**COMMUNICATIONS ALLIANCE
SATELLITE SERVICES WORKING GROUP**

SUBMISSION

Apparatus licences in the 3.4–4.0 GHz band in
remote Australia - Licensing, allocation process,
technical framework and pricing arrangements

4 May 2022

Figure 1: Second FSS Rx above WBB Tx

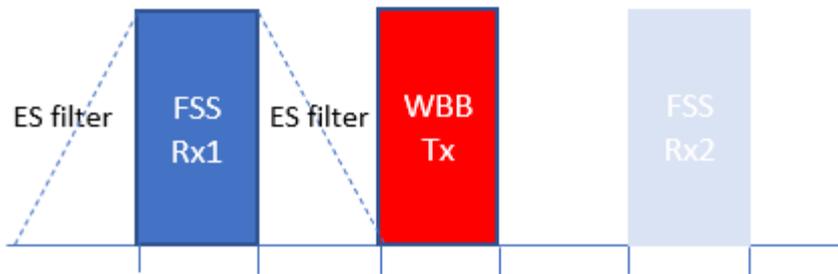
- (e) Often there are multiple carriers licensed on the same antenna. If the 'theoretical' filter assumptions in Table 7 of the draft RALI MS47 are used, and a

second FSS Rx carrier was required on the same antenna, the band-pass filter would not allow the FSS Rx2 signal to be received by the earth station receiver. This limitation would apply for both a second FSS Rx operating above the WBB Tx (see Figure 1) or for a second FSS Rx operating below the WBB Tx (Figure 2).

Taking this into account and as exposed above, filtering sub-parts of the 3400 – 4200 MHz for a specific operation is not practically implementable and therefore filtering requirements should not apply for remote FSS earth station.

The earth station LNB should therefore preserve its capacity to receive in the entire 3400 – 4200 MHz band and WBB Txs operating in the 3400 – 4000 MHz band would be considered as in-band in relation to FSS Rxs. Large separation distances would therefore be required to operate both the WBB and FSS services. Separation distances may be reduced through site coordination by taking into account the specific deployment environment and configuration of both the FSS ES and WBB station.
